Refer to: HSA-10\WZ-75

Thank you for your letter sent January 16 requesting Federal Highway Administration (FHWA) acceptance of your company's Model MGS48A temporary sign stands using aluminum laminate substrate signs as crashworthy traffic control devices for use in work zones on the National Highway System (NHS). Accompanying your letter was a report from E-Tech Testing Services, Inc., and a video of the crash tests. You requested that we find your company's temporary sign stand acceptable for use on the NHS under the provisions of National Cooperative Highway Research Program (NCHRP) Report 350 "Recommended Procedures for the Safety Performance Evaluation of Highway Features."

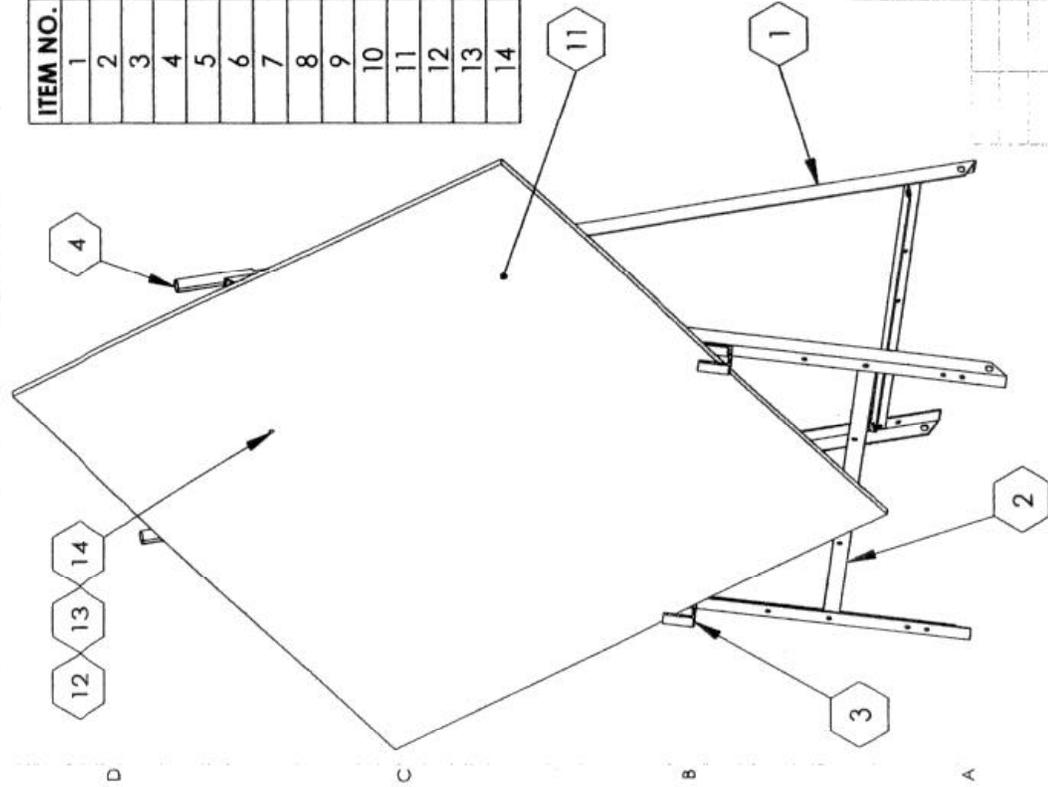
Full-scale automobile testing was conducted on your company’s devices. Two stand-alone examples of the device were tested in tandem, one head-on and the next placed 6 meters downstream turned at 90 degrees, as called for in our guidance memoranda. The complete devices as tested are shown in the Enclosure 1.

Damage in the Reynobond test was limited to cosmetic damage to the sheet metal of the test vehicle. Only minor windshield cracking resulted from the 90 degree impact with the Dibond sign. The results of the testing met the FHWA requirements and, therefore, the MGS48A portable sign stands described above and shown in the enclosed drawings for reference are acceptable for use as Test Level 3 devices on the NHS under the range of conditions tested, when proposed by a State, when used with either 2 mm or 3 mm thick Reynobond or Dibond aluminum laminate signs.
